This SI 142/90 contains information about modifications that have to be done on the D820-48. This set of modifications has been named Version 1.0 .

3. MODIFICATION INSTRUCTIONS

1.328.612-20 .AL Rembus + μ P

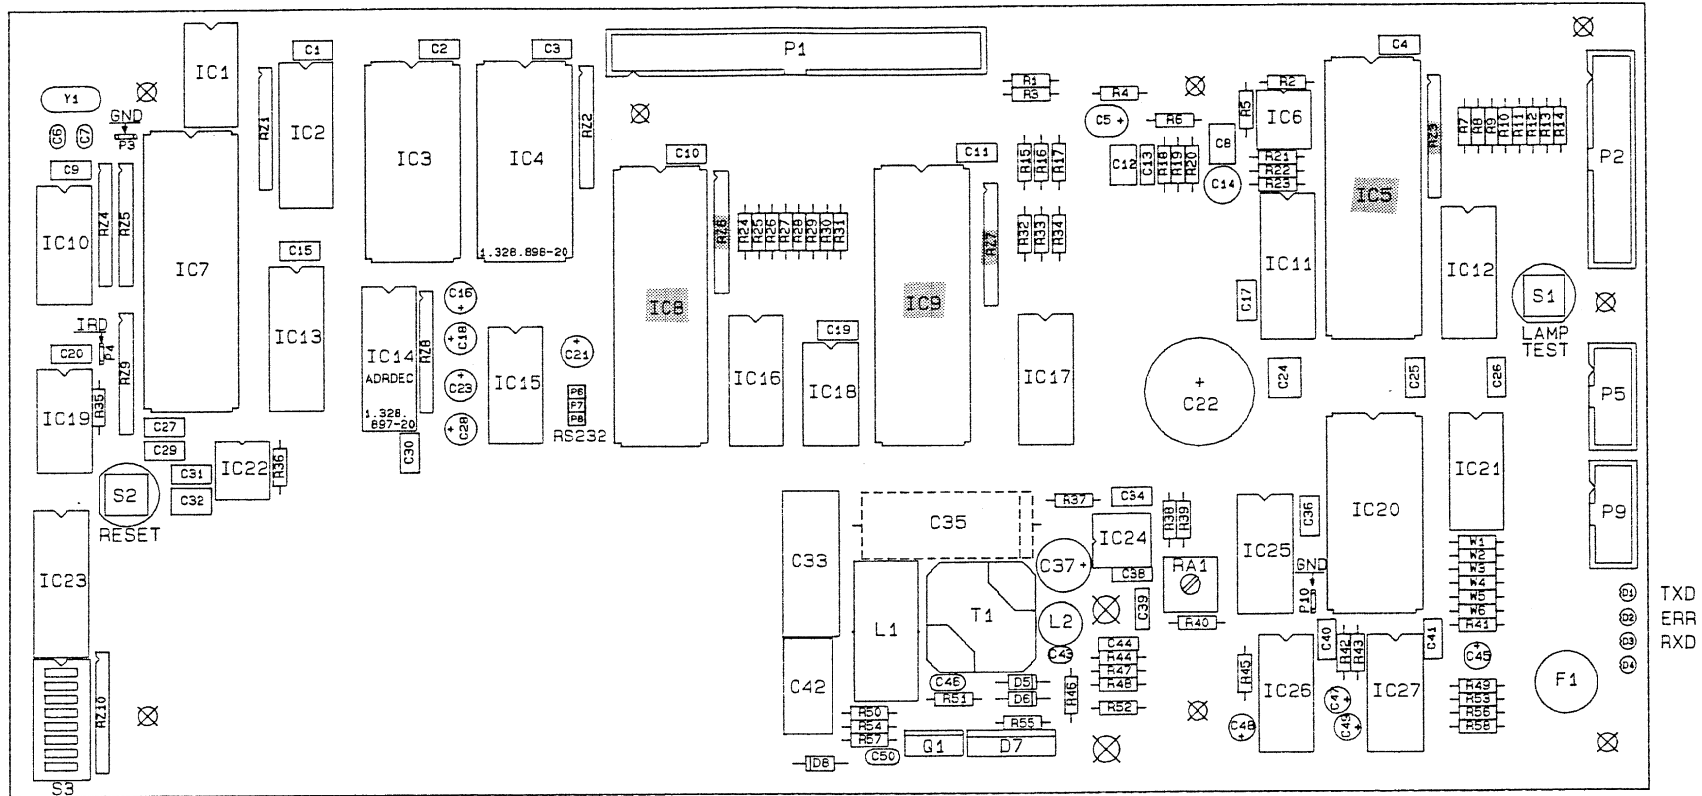
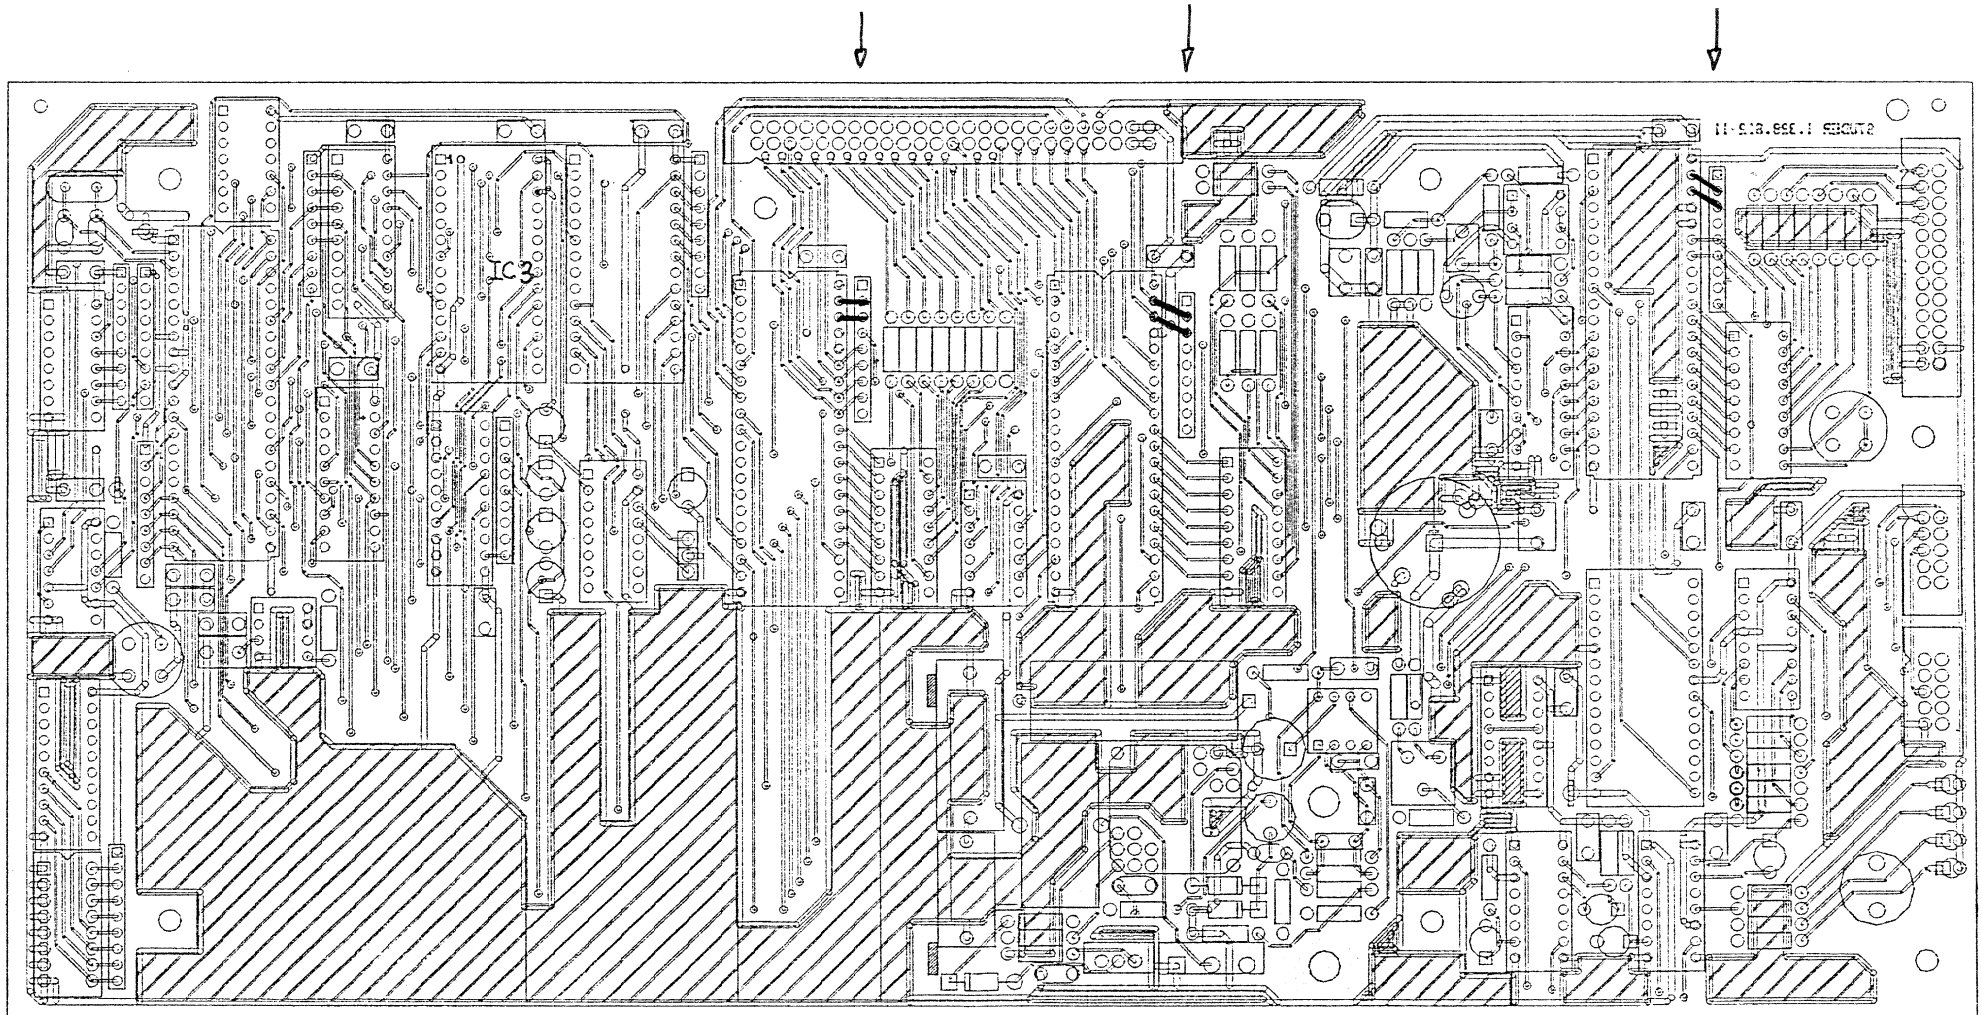
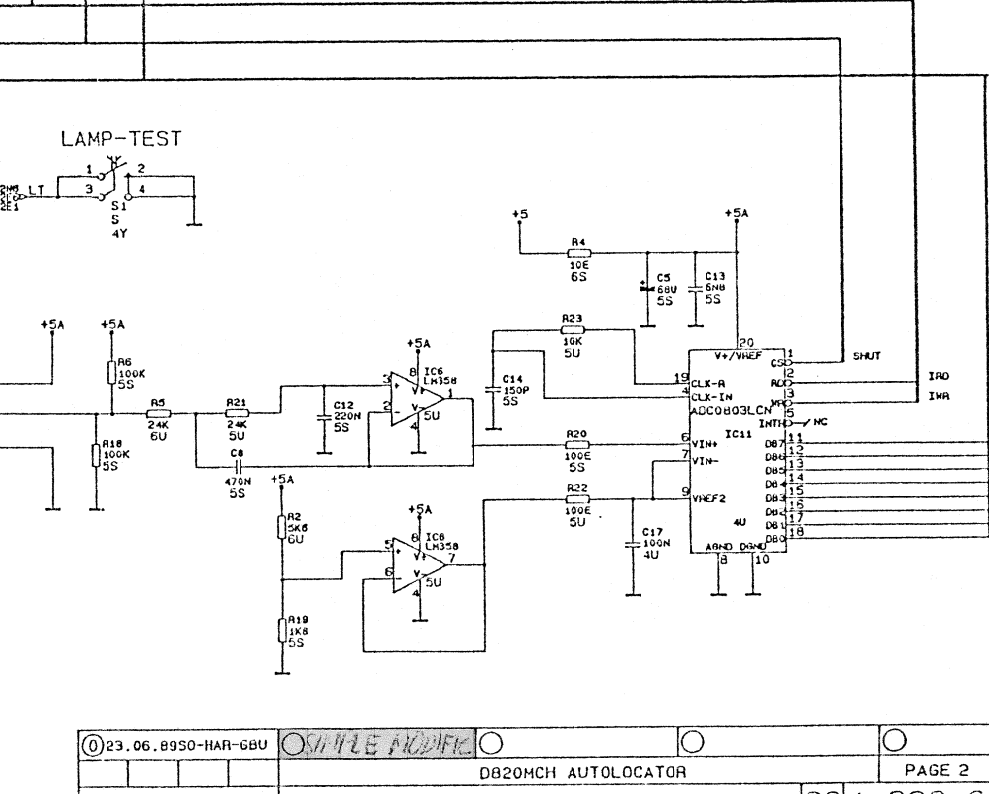
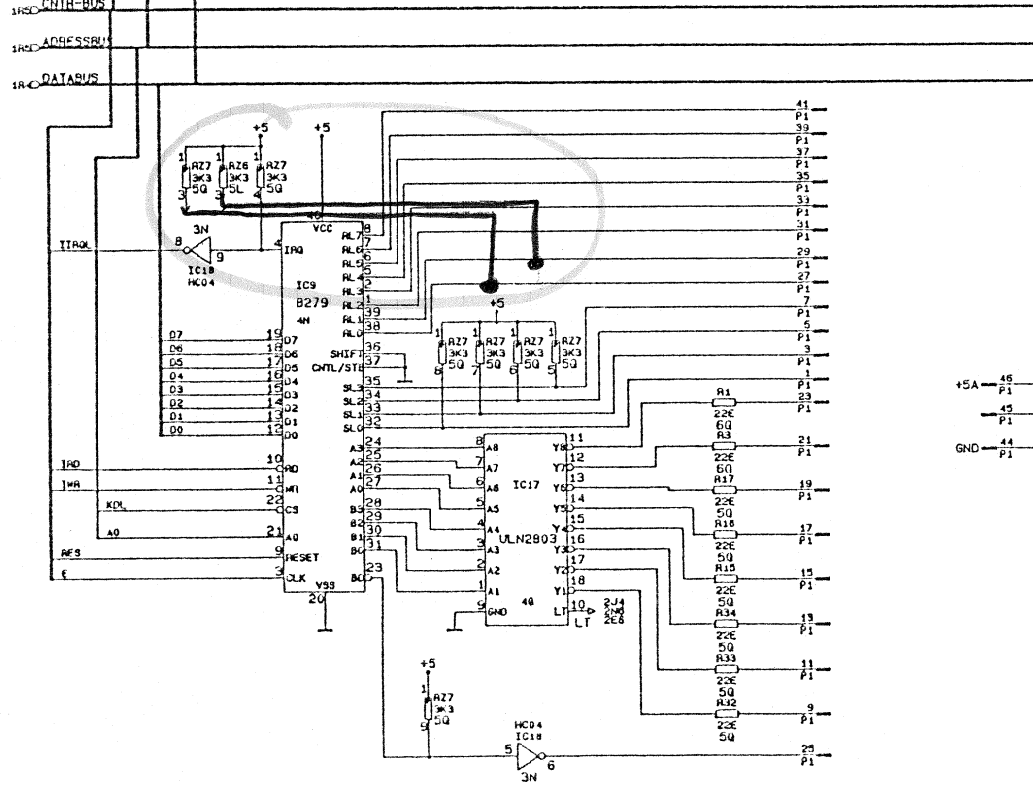
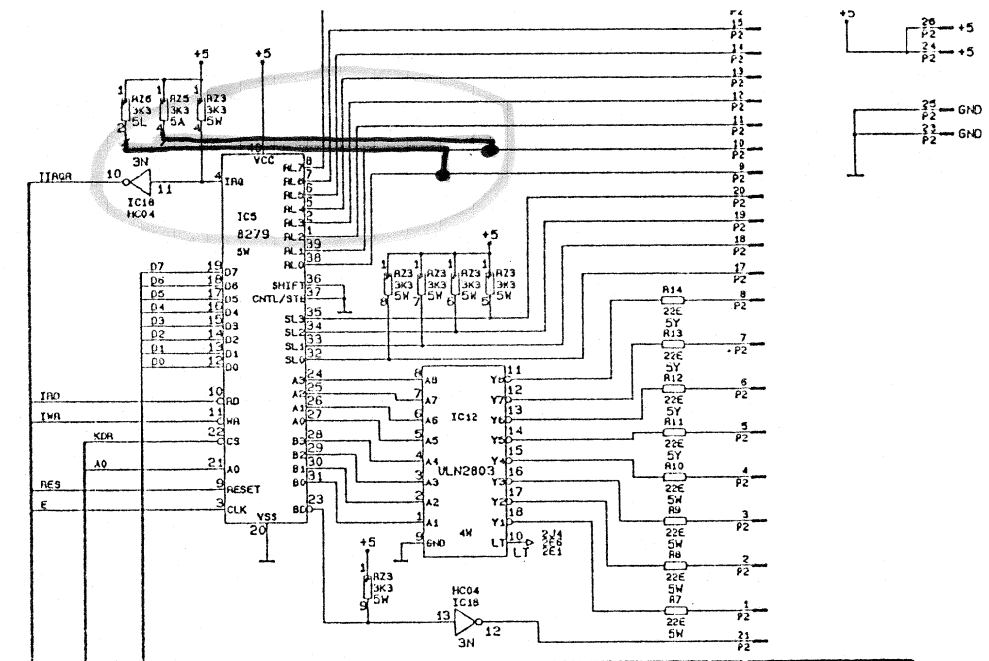
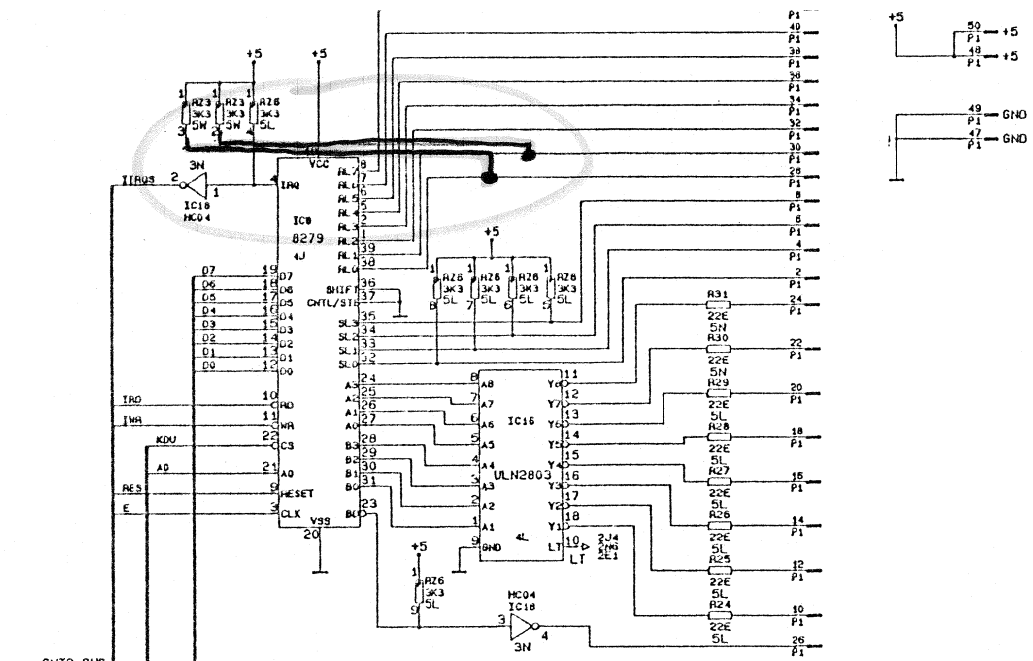
IC 8 to RZ 6	}	Pin 39 (IC) to pin 2 (RZ)
IC 9 to RZ 7	}	PIN 38 (IC) to pin 3 (RZ)
IC 5 to RZ 3	}

Connect pins 38 & 39 of ICs 5, 8, 9 to pins 2 & 3 of RZ 3, 6, 7 respectively
(8279)

→ Add wires on soldering side !

SSTC BOARD
BESTUECKUNGSPLAN

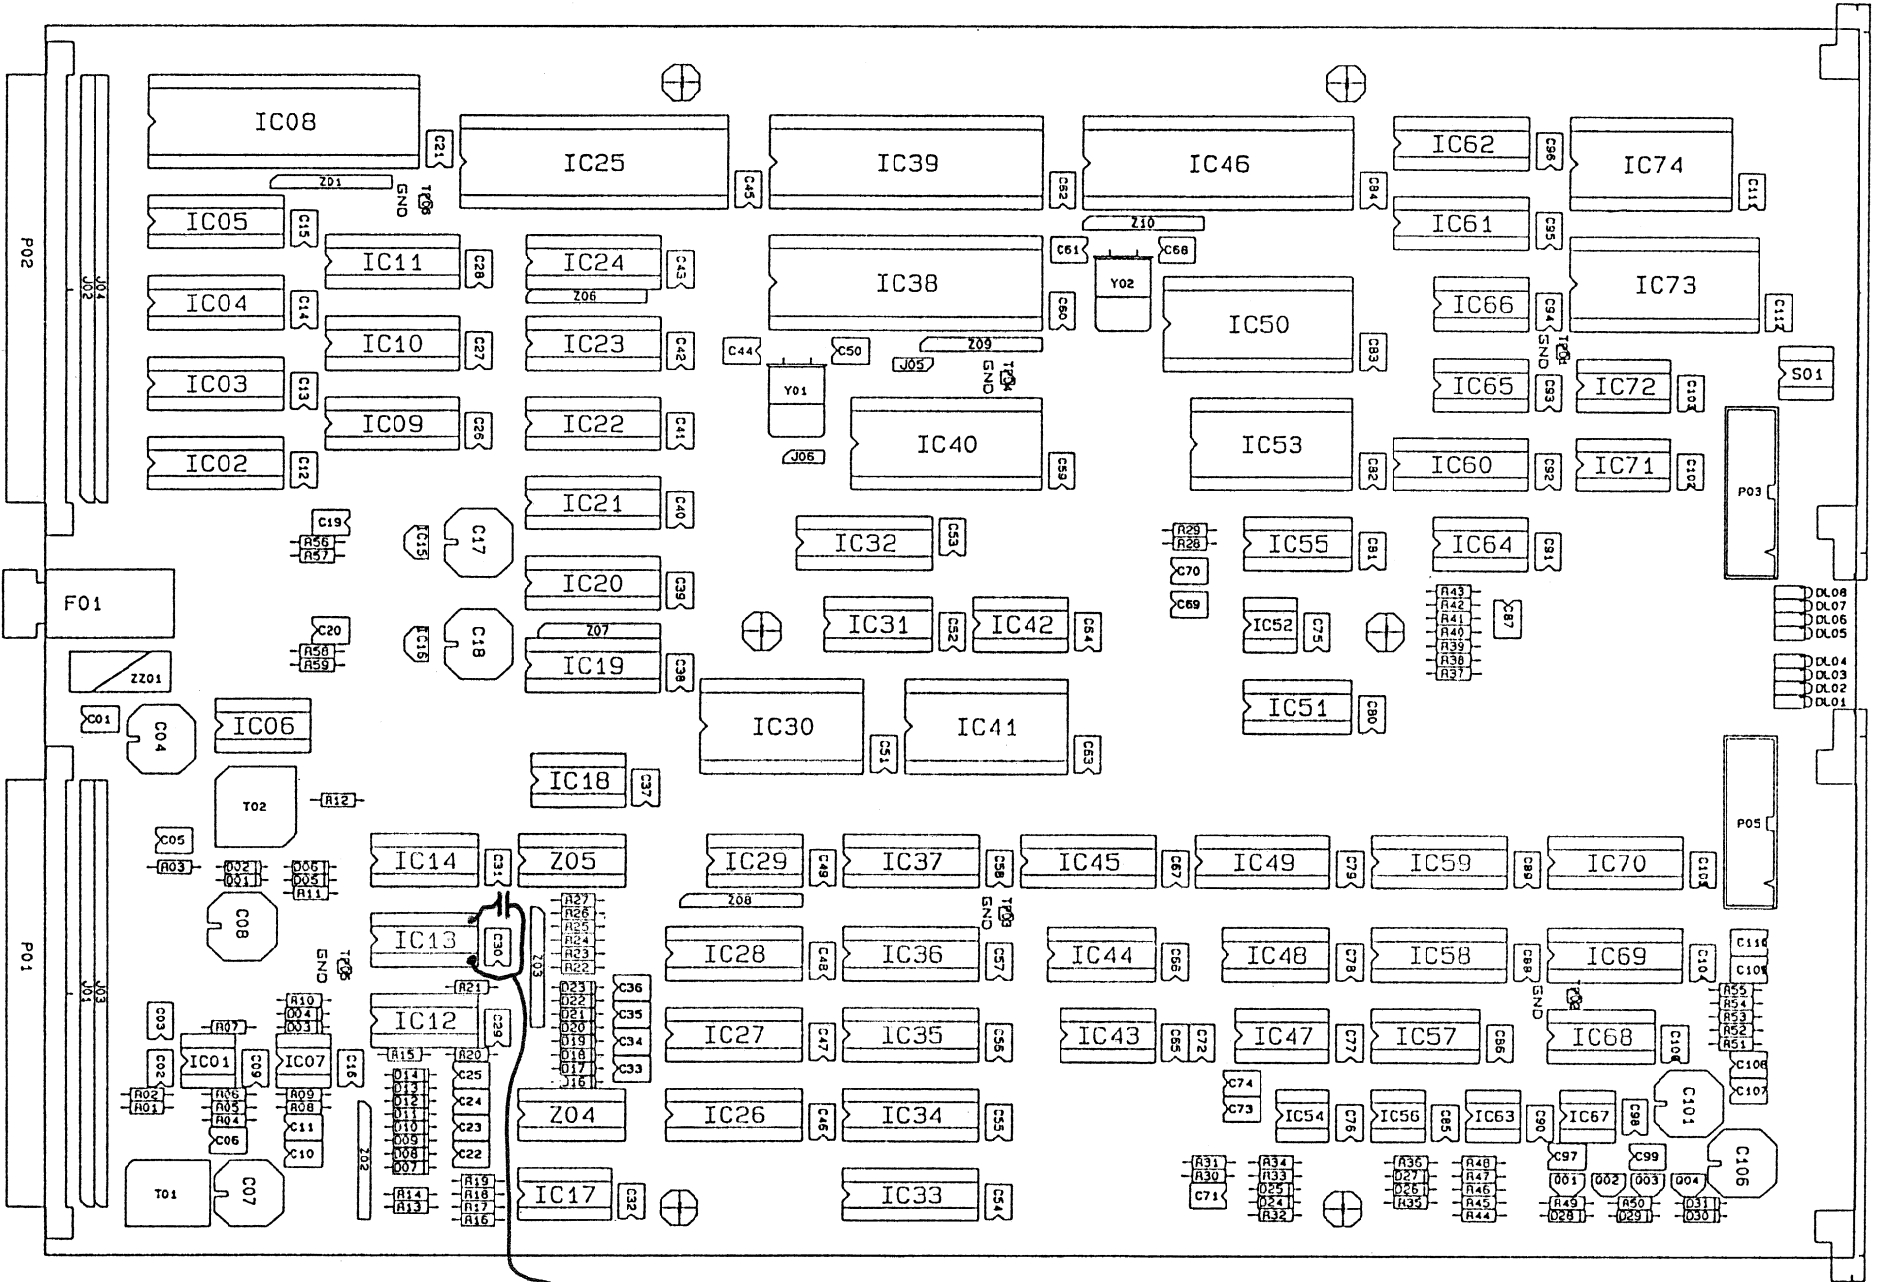
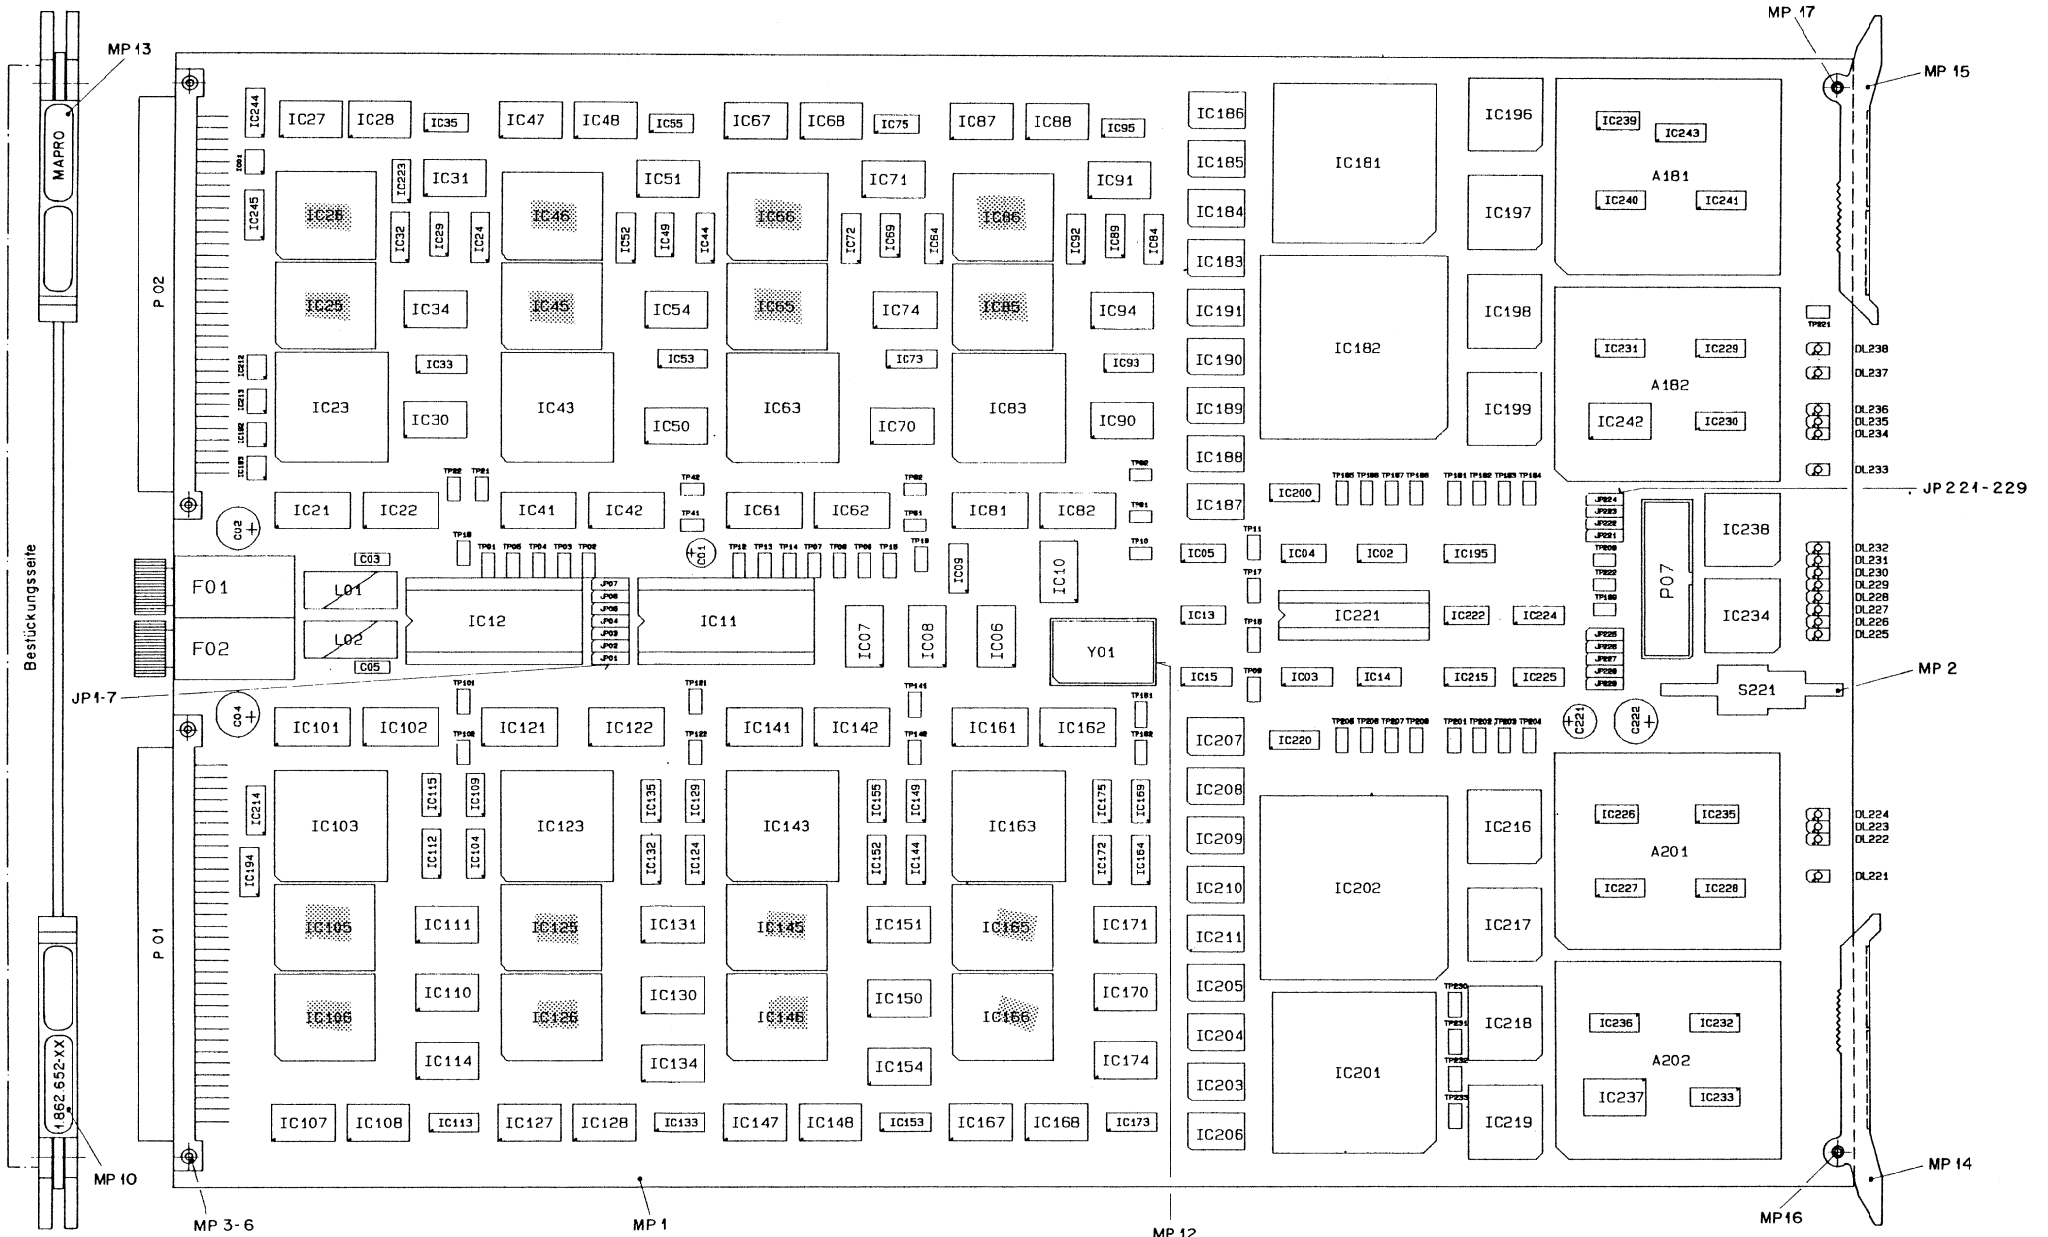
When using external Varispeed (from the SYNCHRONIZER or PARALLEL REMOTE port), the Clock Board is unable to lock to the incoming varispeed signal, because the signal SS-RFNT / SS-IRFNT coming from the SSTC-Board 1.862.659.21 is disturbed.

A capacitor (2.7 nF) across pin 9 and pin 8 (Ground) of IC 13 (26 LS 31) suppresses the disturbance.

(add capacitor on the soldering side)
2n7F
